## 19 STATE AGENCIES

**Palmdale - Burbank - RECORD #4099 DETAIL**

# Submission 4209 (Patrica Michel, Santa Monica Mountains Conservancy, October 21, 2022)

# Submission 4512 (Ruby Kwan-Davis, California Department of Fish and Wildlife, South Coast Region 5, Habitat Conservation Planning Program, December 1, 2022)

CALIFORNIA HIGH-SPEED RAIL AUTHORITY - PALMDALE TO BURBANK PROJECT  
SR14A Segment 2 and Vicinity

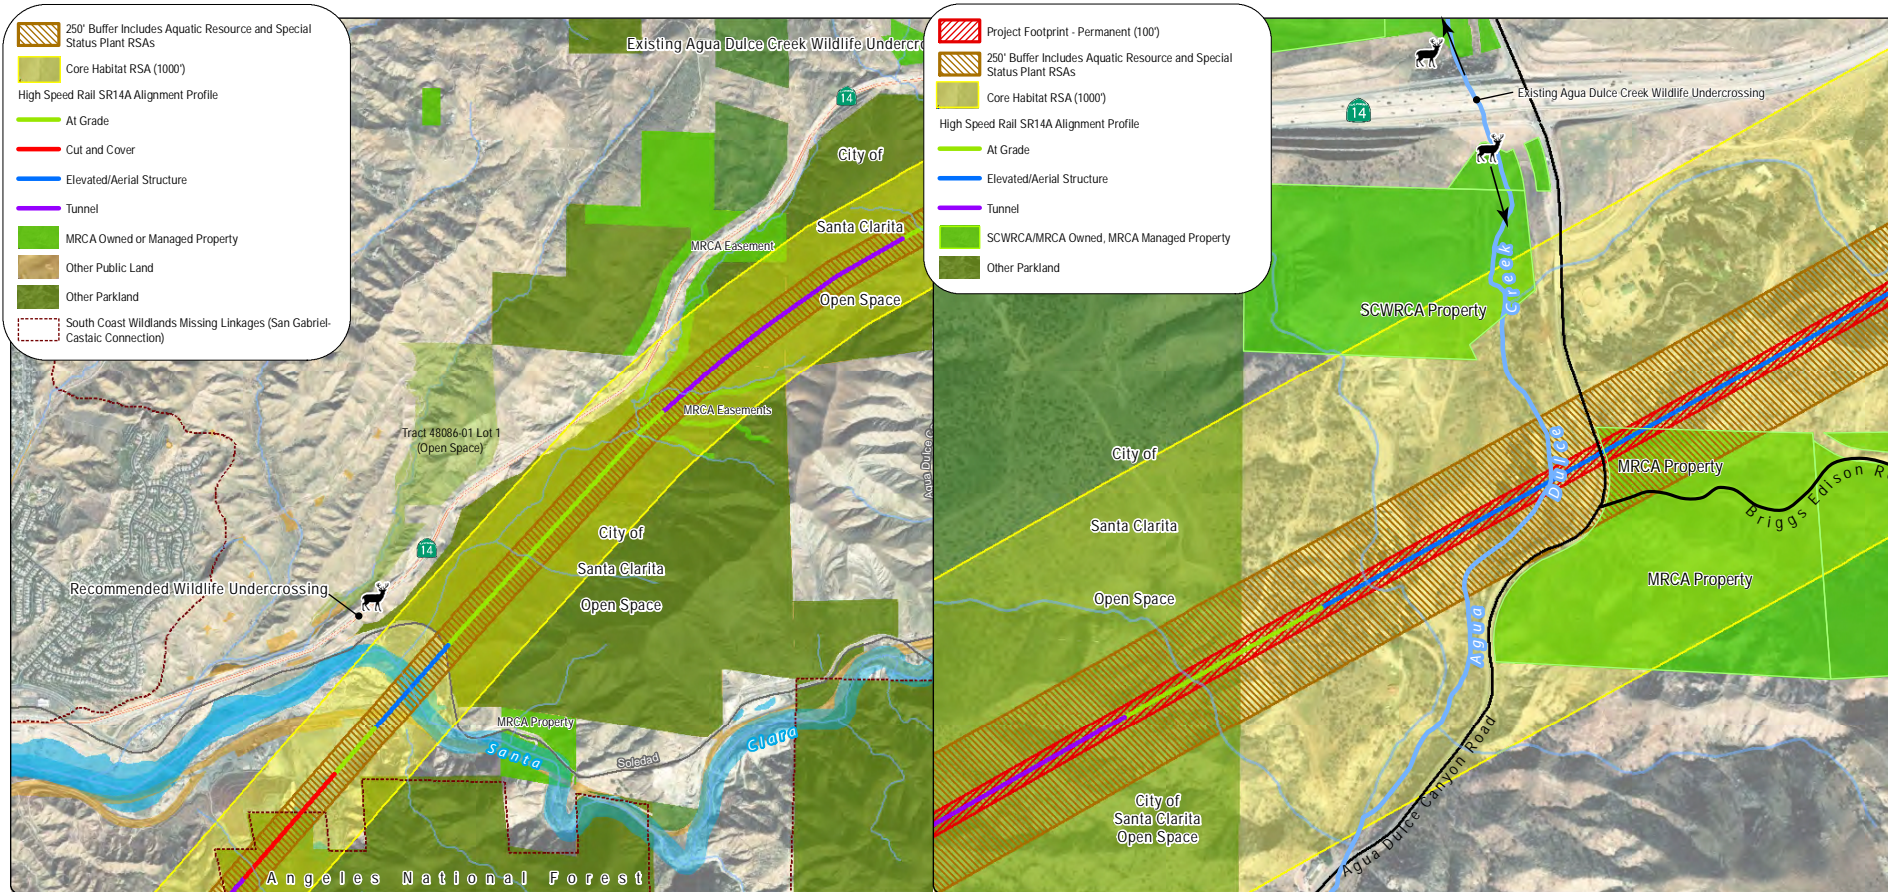
The *San Gabriel – Castaic Connection* identifies a fill slope supporting SR-14 for a new wildlife undercrossing structure to connect Spring Canyon (north of SR-14) with Bee Canyon (south of SR-14). The D-EIR/EIS Figure 3.7-25 (Mountain Lion Habitat within the Resource Study Area) indicates the recommended Spring Canyon – Bee Canyon wildlife crossing structure would directly support mountain lion Breeding and Foraging Habitat connectivity. The D-EIR/EIS Figure 3.7-48 (Wildlife Corridor Impermeability Map: SR14A Build Alternative) shows the proximity of the at-grade SR14A Segment 2 that contributes an additional 1.13 miles of impermeable wildlife barrier to this vital habitat corridor. The Conservancy recommends the Authority coordinate with the California Department of Transportation (Caltrans) to design and construct the recommended SR-14 undercrossing between Spring and Bee Canyons as part of the mitigation for new impacts to terrestrial wildlife movement related to at-grade HSR construction and operation and legacy impacts of SR-14.

The commenter recommends that the Authority coordinate with the California Department of Transportation (Caltrans) to design and construct a new wildlife undercrossing under the SR 14 freeway between Spring and Bee Canyons as part of the mitigation for new impacts to wildlife movement. Section 5.3.1, Existing Crossing Structures in the Wildlife Corridor Assessment (WCA) Report (Authority 2019c) identifies those structures that could provide crossing opportunities for wildlife movement across the SR 14 freeway. Photographs of each of the crossing opportunities are provided in Appendix C of the WCA. Figure 4-5 in the WCA shows the spatial relationship between the project and existing bridges. As shown in Table 6-6 in the WCA and Table 2-13 of the supplemental WCA (Authority 2019c), the SR14A Build Alternative includes six permeable segments that include a 13.25-mile, 8.28-mile, and 1.04-mile tunnel segments where wildlife can cross over the alignment. Furthermore, the SR14A Build Alternative includes a 0.43-mile, 0.40-mile, and 0.19-mile elevated viaduct segment where wildlife can cross underneath the HSR alignment. Similarly, the Refined SR14 Build Alternative includes a 13.06-mile, 7.21-mile, 3.14-mile, 1.62-mile, 0.99-mile, and 0.51-mile tunnel segment where wildlife can cross over the alignment. Furthermore, the Refined SR14 Build Alternative includes a 0.68-mile, 0.65-mile, 0.44-mile, 0.37-mile, 0.32-mile, 0.16-mile, 0.06-mile, and 0.03-mile elevated viaduct segment where wildlife can cross underneath the HSR alignment. Figure 4-5 of the WCA shows the existing crossings under the SR 14 freeway align with large tunnel and viaduct sections of the Refined SR14/SR14A Build Alternatives that would maintain wildlife movement.

Regarding the recommended undercrossing at the SR 14 freeway between Spring and Bee Canyons; the SR 14 freeway would be permeable to wildlife movement at Bee Canyon, as described above. For example, the Stonecrest Road –SR 14 freeway undercrossing identified in the WCA provides a connection from Spring Canyon (referenced by the commenter) to the north of the SR 14 freeway to the Santa Clara River where wildlife can cross underneath a 0.4-mile-long elevated viaduct. Figure 4-4 of the WCA and Figure 2-10 in the supplemental WCA show the Linkage Design and the 0.4-mile elevated viaduct adjacent to the Stonecrest Road undercrossing. Implementation of the Build Alternatives would not constrain wildlife movement in Bee

Figure 1 –Aerial photograph showing wildlife movement opportunities, looking north from Agua Dulce Canyon Road, through the Linkage Design, across the SR 14 freeway corridor with UC Davis Wildlife-Vehicle Conflict Hotspots identified.

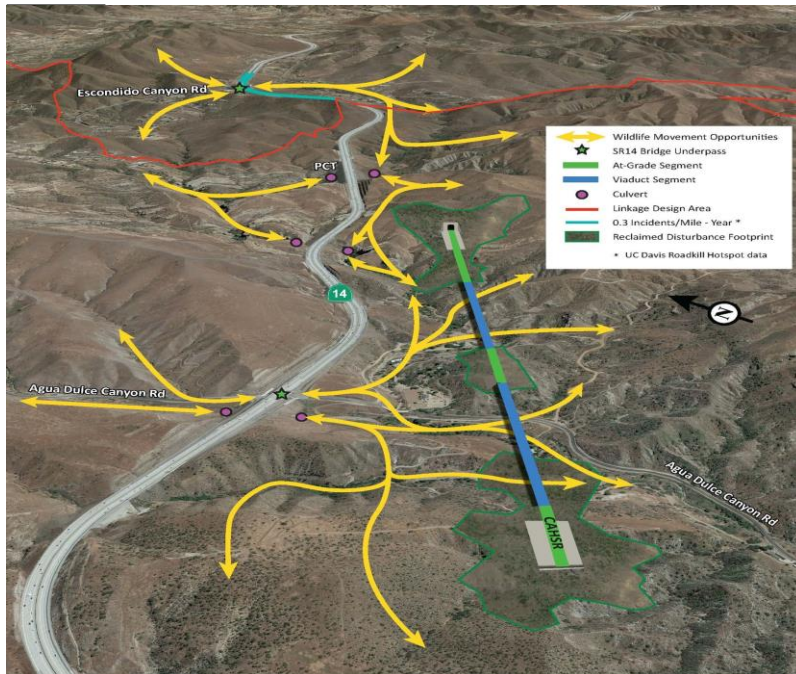
4512-10544

The commenter expresses concern about the almost 1-mile-long, 1,000-foot-wide barrier adjacent to the ANF and within the Linkage along Bee Canyon that would result from the track corridor, grading footprint, and detention basins (noting that there is substantial permanent and temporary grading and disturbance on both sides of the track shown in Appendix 3.1-A Palmdale to Burbank: Footprint Mapbook, Maps 21 and 22). Although the temporary grading footprint may extend to 1,000 feet in some areas, these areas will be restored to native habitat that will be available for wildlife use and movement, pursuant to BIO-MM#6. With respect to the barrier, the project has extensive

Figure 2 –Aerial photograph showing wildlife movement opportunities, looking north from Stonecrest Road, through the Linkage Design, across the SR 14 freeway corridor with UC Davis Wildlife-Vehicle Conflict Hotspots identified.

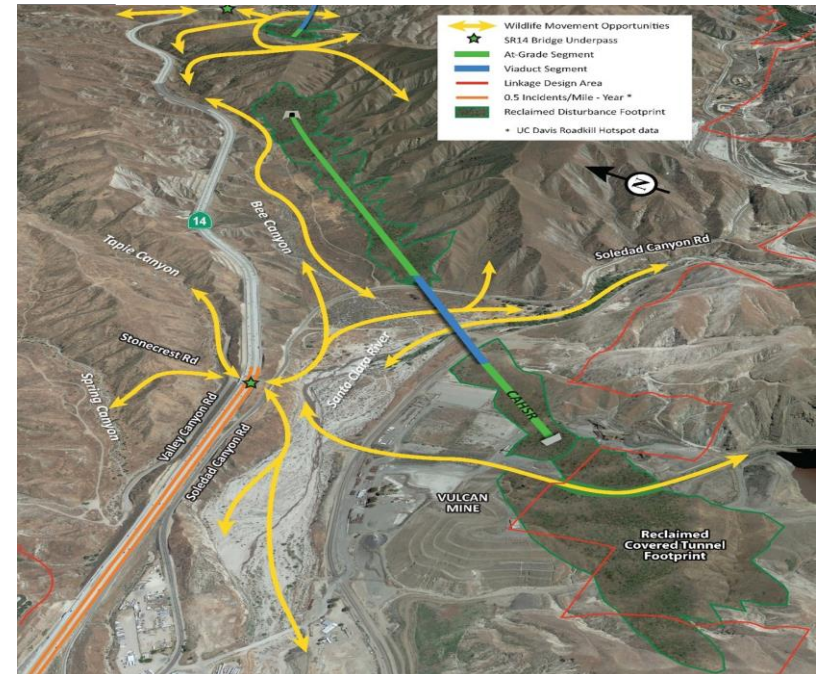
4512-10544

existing crossing opportunities, which are corroborated by the recent UC Davis data on high wildlife use hotspot areas. As described above and shown in Figures 1 and 2, the Refined SR14 Build Alternatives and SR14A Build Alternatives contain a large network of tunnels and viaducts that align with the existing crossing opportunities [existing bridges and high wildlife use hotspot areas (UC Davis 2023)] to maintain existing wildlife movement opportunities and gene flow. As such, a mountain lion crossing monitoring plan is not required.
